Access Compliance Report

Public Rights-of-Way

Intersection ID: 47087	Main Street: MARVIN_RD	Cross Street: COVENTRY_COURT_LN	Location: E
ADA ID: 8FB707AF3AC9	Ramp Type: PerpDiag	Initial Pass/Fail: Fail	Overall Compliance: No
Severity Score: 12.5			
Codes/Mitigation Info/Possible Solution		Field Measurements/Component Compliance

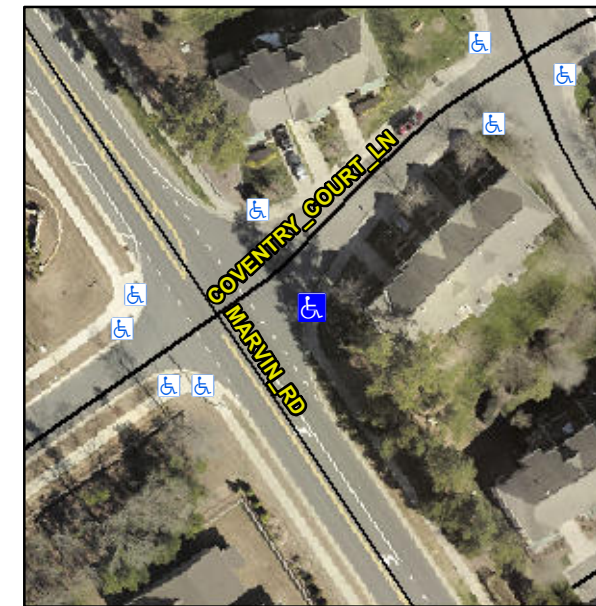
Not Found, R304.2.2

Compliance	Description	Data	Compliance	Description	Data
N/A	Ramp Length (in)	61.0	No	Ramp Slope (%)	9.1
Yes	Ramp Width (in)	48.0	Yes	Ramp XSlope (%)	1.7
N/A	Flare Type LT	N/A	N/A	Flare Type RT	N/A
N/A	Flare Slope LT (%)	N/A	N/A	Flare Slope RT (%)	N/A
N/A	Flare Traversable LT?	N/A	N/A	Flare Traversable RT?	N/A
N/A	Landing Length (in)	N/A	N/A	DWS Provided?	N/A
N/A	Landing Width (in)	N/A	N/A	DWS Contrast?	N/A
N/A	Landing Slope (%)	N/A	N/A	DWS Length (in)	N/A
N/A	Landing X Slope (%)	N/A	N/A	DWS Full Width?	N/A
N/A	Landing Curb? (Y/N)	N/A	N/A	DWS Offset (in)	N/A
N/A	Shared Landing?	N/A			
N/A	Gutter Ponding?	N/A	N/A	Gutter Slope (%)	N/A
N/A	Gutter Lip Ht (in)	3.0	N/A	Gutter X Slope (%)	N/A
N/A	Painted X Walk1?	No	N/A	Painted X Walk2?	No
	X Walk 1 Direction	To NW		X Walk 2 Direction	To SW
N/A	X Walk 1 Width (in)	N/A	N/A	X Walk 2 Width (in)	N/A
	X Walk 1 Slope (%)	2.1		X Walk 2 Slope (%)	1.5
	X Walk 1 X Slope (%)	1.7		X Walk 2 X Slope (%)	0.1

Remove & Replace Curb Ramp With Two New Directional Ramps or Equivalent.
